## MEMORANDUM

**TO:** MPE Inc.  
**FROM:** David Eldredge  
**SUBJECT:** Woodruff Drawing Analysis  
**DATE:** November 17, 2017

**SOUTH SECTION B**  
 NORTH SIDE: 22  
 SOUTH SIDE: 2.0  
 42 x 500 = 21,000 + 2,000 = 10.5 U.S.

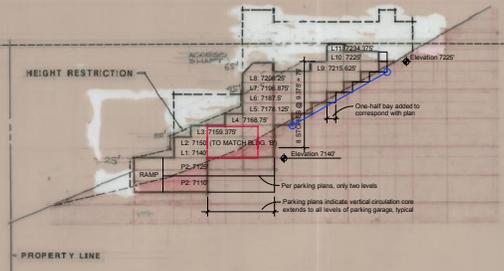
When the plans for the five main buildings are compared to the corresponding sections the lengths of four of the buildings are inconsistent. The sections of Buildings A & C are one-half bay too short, Building D is a full bay short, and Building E is one bay too long.

On Sections A & B it appears there are either three levels of parking, or two levels of parking as shown on the parking plans, plus one level of habitable space that's not shown on the site plan. On Sections C-E only four levels of parking are indicated, whereas the parking plans indicate five.

**NORTH SECTION A**  
 NORTH SIDE: 24  
 SOUTH SIDE: 2.2  
 49 x 500 = 24,500 + 2,000 = 12 U.S.

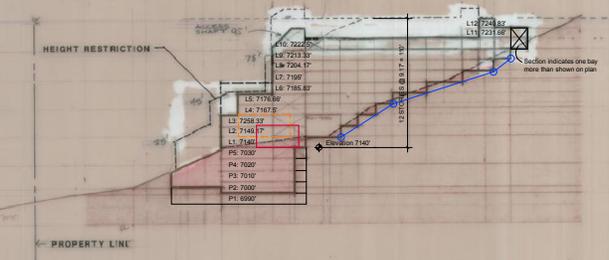
On the Midstation parking plans no floor elevation is noted for the first level, but on the second level plan the entry, and therefore presumably the first level, is noted as elevation 7105', whereas on the Section A it's 7110'. As the southerly portion of the second level is noted on the plans as sloping it's difficult to compare with the section. However, based upon the elevations noted the slope for this portion of the garage is approximately 15%, or three times the maximum allowed by code (slopes in excess of 5% qualify as ramps, requiring handrails and intermediate landings). Furthermore, on the sections the top of the parking garage and first level of units coincide, making no provision for the sloping ski trail overhead. Both of these issues would need to be resolved by lowering the Midstation garage, resulting in additional excavation.

**SECTION E**  
 NORTH SIDE: 6.8  
 SOUTH SIDE: 6.0  
 12.8 x 500 = 64,000 + 2,000 = 32 U.S.

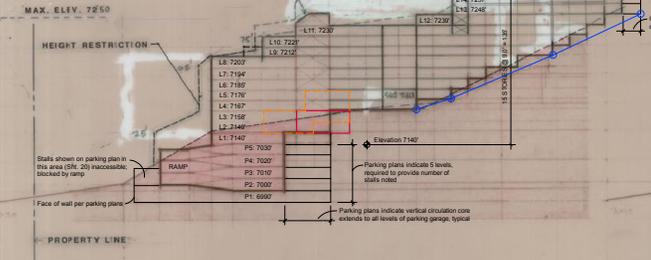
Clearly the path of the ski trail through the Creole site was given minimal consideration. Sections D & E do indicate an opening through the buildings to accommodate the ski trail, but given the
